# UNITED STATES PATENT AND TRADEMARK OFFICE

APPLICATION NO.	FILING DATE	FIRST NAMED INVENTOR	ATTORNEY DOCKET NO.	CONFIRMATION NO.
10/537,212	04/03/2006	Karlheinz Freywald	D4695-00134	1864
8933	7590	06/08/2009		
DUANE MORRIS LLP - Philadelphia			EXAMINER	
IP DEPARTMENT			PATEL, REEMA	
30 SOUTH 17TH STREET				
PHILADELPHIA, PA 19103-4196			ART UNIT	PAPER NUMBER
			2812	
			MAIL DATE	DELIVERY MODE
			06/08/2009	PAPER

## **DETAILED ACTION**

Fig. 16. 4A.

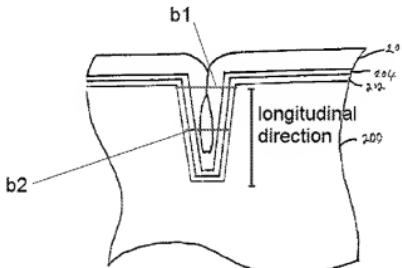
5. Regarding claim 1, Campana discloses a method for sealing an isolation trench, wherein each of the trenches has a first width (b1) and is slightly broadened (b2) at a specific trench portion longitudinally adjacent to the first width (see examiner-marked

Fig. 4a, below), wherein a low pressure deposition technique is used such that a void channel is formed in an area of each trench having the first width (b1) by closing an upper trench portion with a fill material and hermetically sealing each trench in the longitudinal direction of by low pressure material deposition from the broadened trench portion and along the length direction of each trench ([0033]-[0034]; Fig. 4a).

6. It is noted that there is no indication that b2 must be wider than b1, only that it is 'slightly broadened' as compared to some reference width. Additionally, the longitudinal direction is the vertical depth of the trench.
